Limerick Generating Station, Units 1 and 2
Facility Operating License Nos. NPF-39 and NPF-85
NRC Docket Nos. 50-352 and 50-353

Subject: License Amendment Request – Table 3.3.2-2, Item 4e, HPCI Equipment Room
Delta Temperature High Isolation Trip Setpoint and Allowable Value Changes

SUBJECT: TS Table 3.3.2-2, Item 4e, HPCI Equipment Room Delta Temperature High Isolation Trip Setpoint and Allowable Value Changes

Page 3/4 3-19

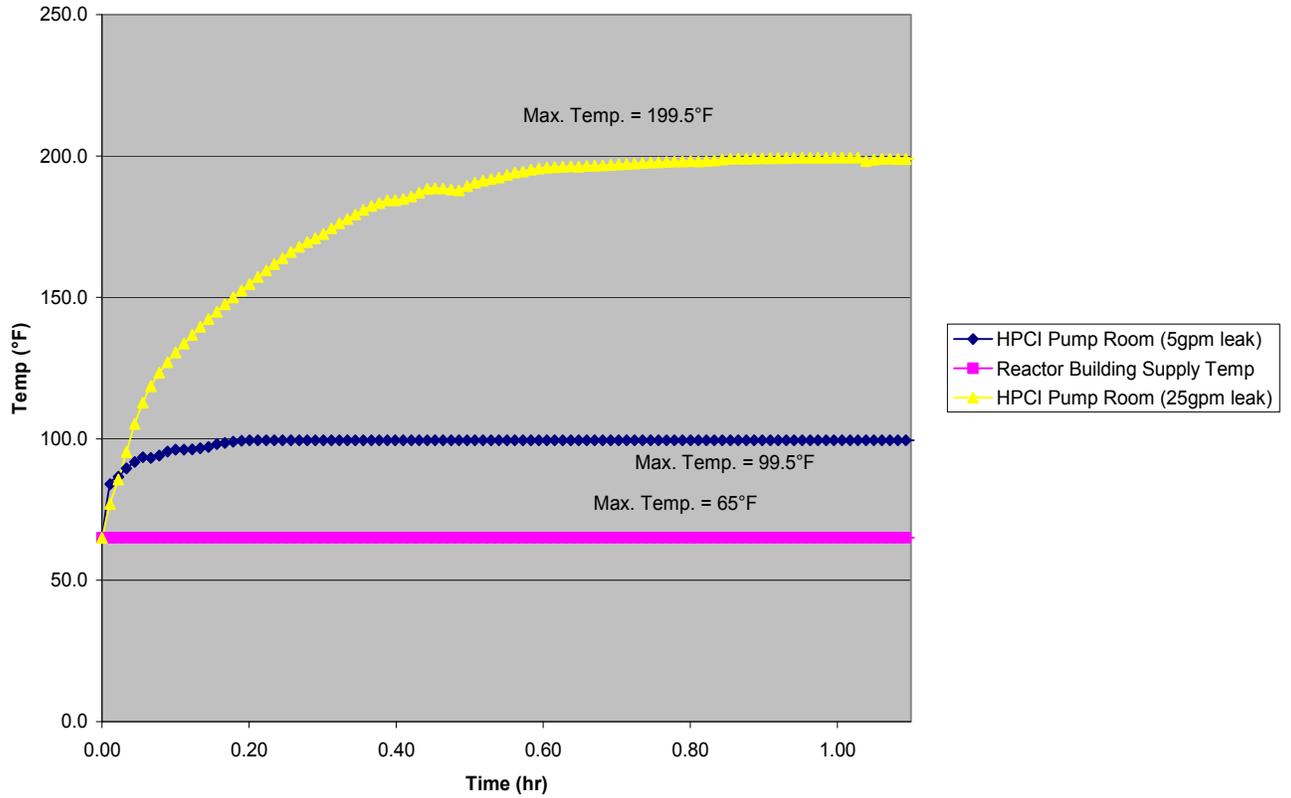
This license amendment request will lower the current non-conservative TS Table 3.3.2-2, Item 4e, HPCI Equipment Room Delta Temperature High Isolation Trip Setpoint from ≤ 126 degrees F to ≤ 104 degrees F. The corresponding AV will be lowered from ≤ 130.5 degrees F to ≤ 108.5 degrees F. The proposed setpoints will ensure that a 25 gpm HPCI steam line leak will be isolated on HPCI high room differential (exhaust minus supply) temperature.

d. HPCI Equipment Room Temperature - High	225°F	$\geq 218^{\circ}\text{F}$, $\leq 247^{\circ}\text{F}$
e. HPCI Equipment Room Δ Temperature - High	$\leq 126^{\circ}\text{F}$ 	$\leq 130.5^{\circ}\text{F}$

The proposed changes revise the High Pressure Coolant Injection (HPCI) Equipment Room Delta Temperature High Technical Specification (TS) Trip Setpoint and Allowable Value (AV) listed in Table 3.3.2-2, Isolation Actuation Instrumentation Setpoints, Item 4e, for LGS, Units 1 and 2. The HPCI Equipment Room Delta Temperature High Trip Setpoint will be lowered from ≤ 126 degrees F to ≤ 104 degrees F and the AV will be lowered from ≤ 130.5 degrees F to ≤ 108.5 degrees F.
